Advice on 1st Assessment Comments

Advice on 1st Assessment Comments - Text

Application Number: 2005100966408

This application relates to a method and system for accessing subterranean deposits from the surface. After assessment, the following assessment opinions are presented.

图 1

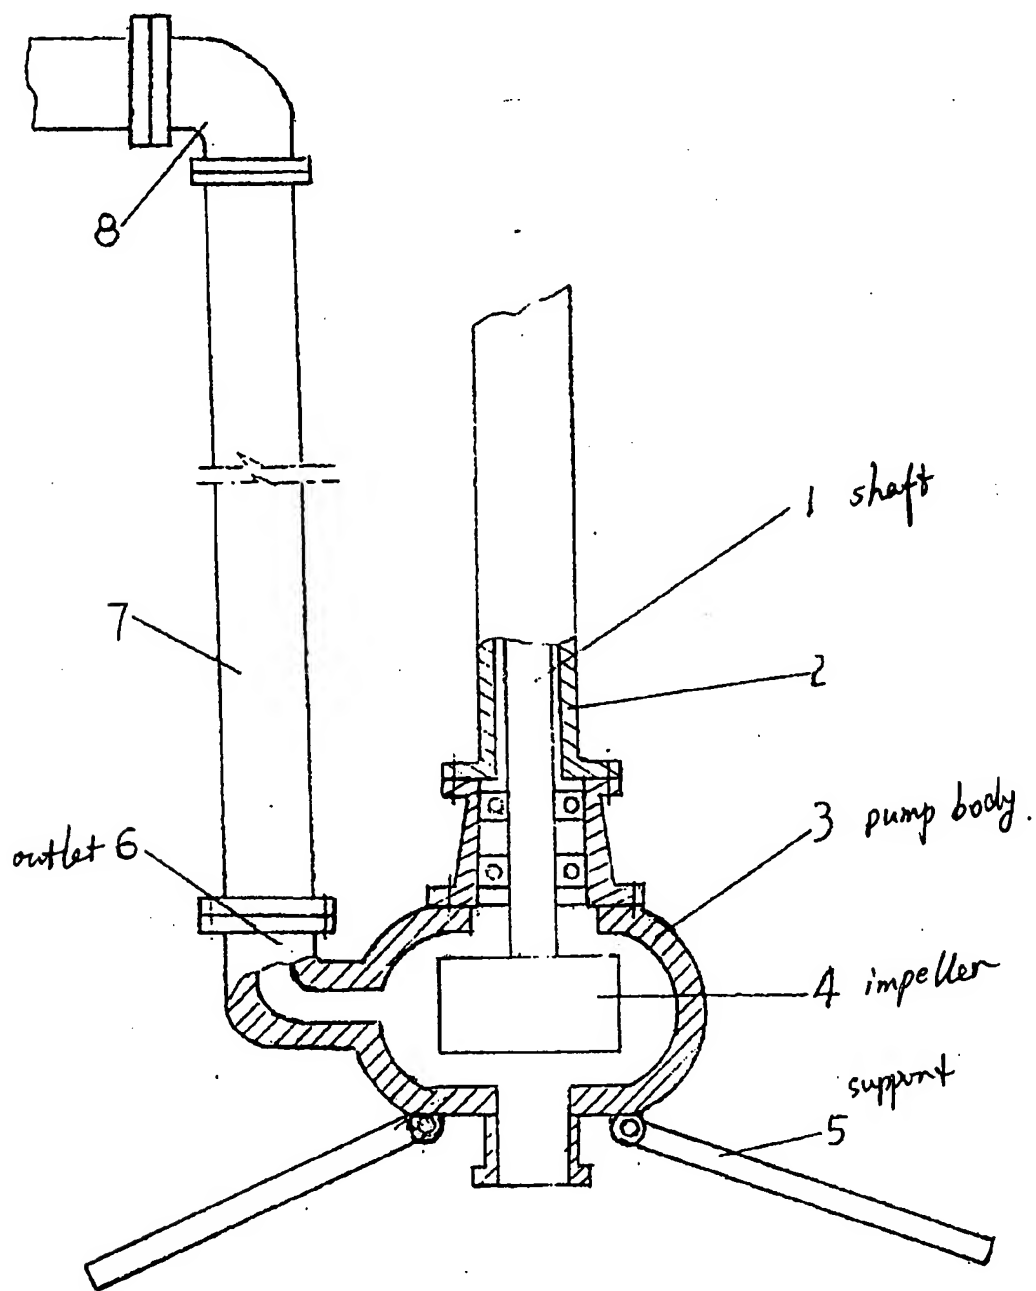
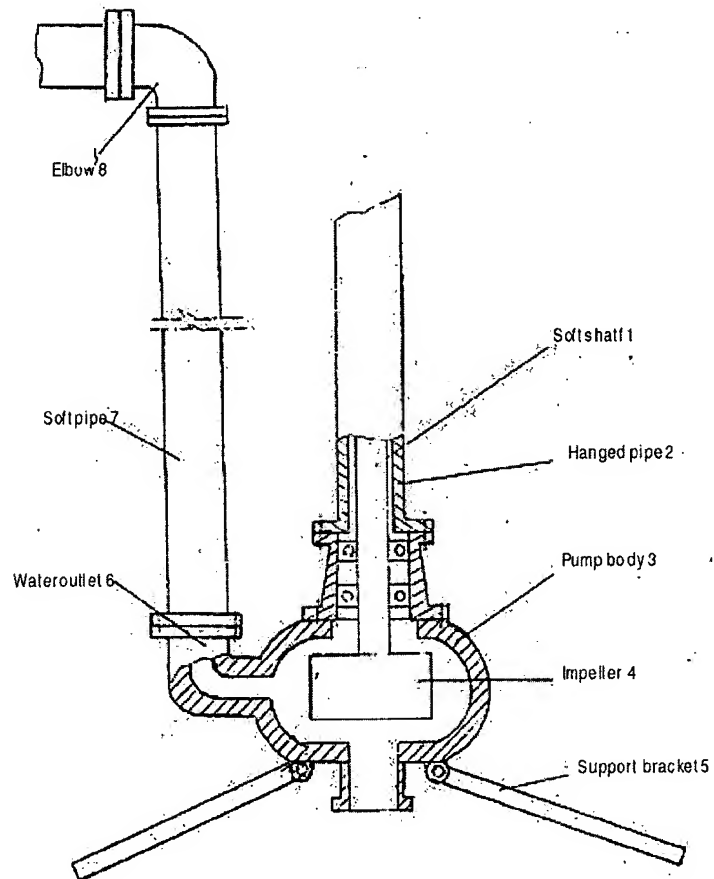
1. The technical scheme for which protection is claimed by Claim 1 does not possess novelty as stipulated under Clause 2 of Article 22 of the Patents Act. The comparison document 1 (CN2248254Y) discloses a soft-shaft deep well water pump, and in particular, a soft-shaft deep well water pump having the following characteristics: "A soft-shaft deep well water pump, wherein the pump body has an inlet portion (i.e. well bore portion) at its bottom that may extract fluid from the well, and the pump body has a retractable support bracket under it for its mounting onto the well wall (cavity positioning device); and the retractable support bracket is extended from a first position in the well to a second position to have the inlet portion positioned at a predetermined position in the well" (refer to Claim 1 and pages 1 - 2 and Figure 1 of the Prospectus for details). ...

... Comparing the contents disclosed in the comparison document 1 and the technical scheme for which protection is claimed by Claim 1, there is only a slight difference in literal expression. Both schemes fall within the same technical field, solve the same technical problems and produce the same technical result of positioning water pump in well. Therefore, the technical scheme for which protection is claimed thereby does not possess novelty.

The Applicant is required to reply within the time period specified by this advice addressing one by one all queries raised in this advice and to revise the patent application documents based on the comments of this advice. In particular, the Applicant is required to revise independent claims and the relevant dependent claims based on the comparison document cited by this advice, and to discuss in its statement of opinions the reasons of the newly revised independent claims possessing novelty and creativeness relative to the techniques existing prior to the application dates mentioned in the comparison document cited by this advice and relative to the techniques existing prior to the application dates mentioned in the original prospectus. In addition, the prospectus must be adjustably revised based on the revised claims. Revision of the application documents by the Applicant must be in conformity with the provision of Article 33 of the Patents Act and must not go beyond the scope of recording of the original prospectus and claims.
